No. L.S. 1665 of 1920

NOTICE UNDER SECTION 96 OF ACT III OF 1901.

PLAN SHOWING PROPOSED STABLES

ON PLOT NO 51A, SHEET K.2, LYAREE QUARTER.

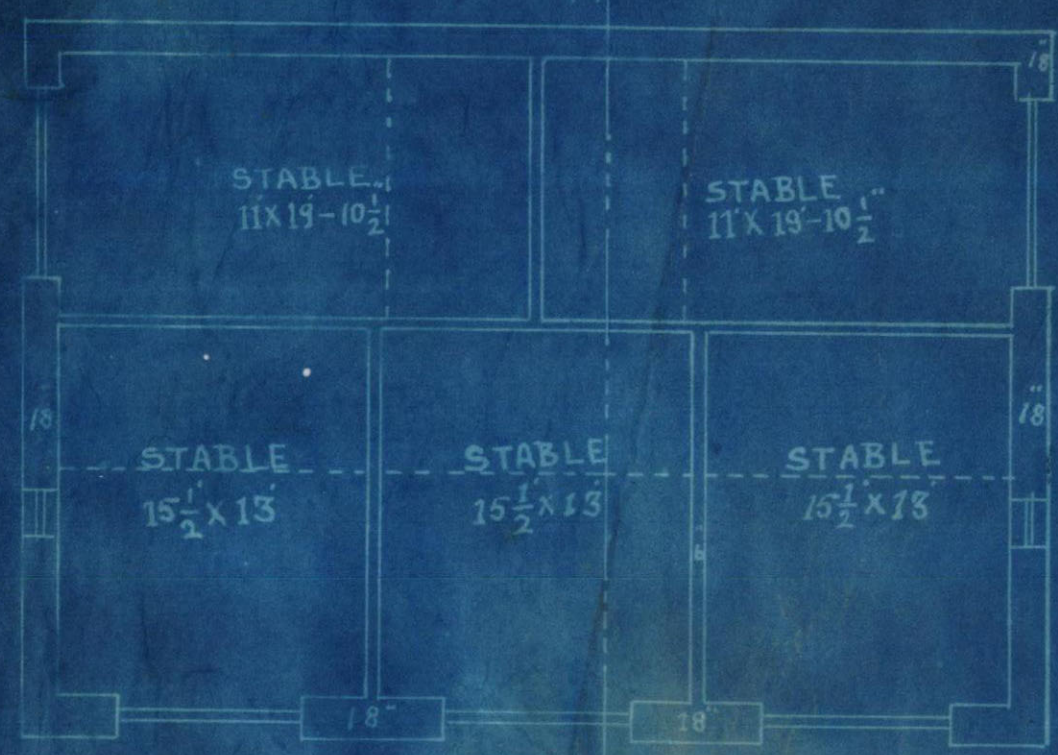
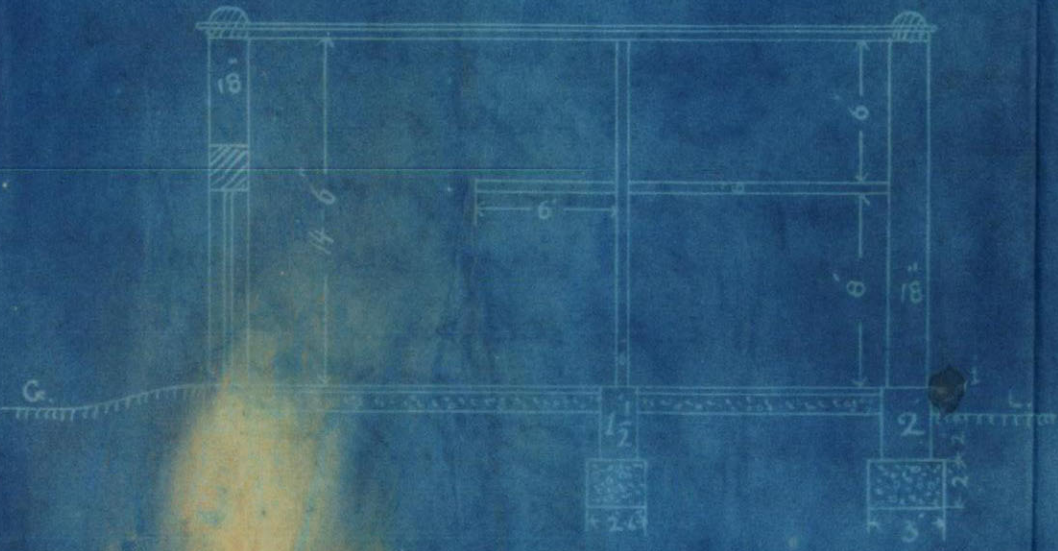
With reference to his application with plan received on 23rd February 1920 regarding building on plot No. 51A, K-2 Lyari quarter Mr. Khushiram Asardas is informed the design is quite unfitted for stable. If carriages are to be kept on the plot proper coach houses separate from the stables must be provided. Provision must be made for sleeping the syce.

2. It is not shown what material the 6" partitions are to be made of.
3. The duchatis must be deleted from the plan.
4. All stables must be properly paved and drained.

Pavement & drains required

Building Surveyor's Report Sir with respect to this I beg to report.
The loft in the stables is contrary to the
rules. and cannot be allowed. unless a head
room of clear 8' is left to the size of the windows
in the stables to the north & south of the floor
could be increased otherwise there appears no
objection to the plan being approved.
J. J. Jaffer
 Date 27-2-1920 Building Surveyor

Remarks Sir, I beg to report that the
site is for living purposes the stables
should not be allowed. the loft is
contrary to the by laws.

The design is quite unfitted for stables.
if carriages are to kept on the plot
proper Coach houses separate from
the stable must be provided. this provision
must be made for aligning the rails.
It is not shown what materials the
partitions are to be made of.
The duck stairs must be
deleted from the plan.

Plans are herewith returned disapproved.
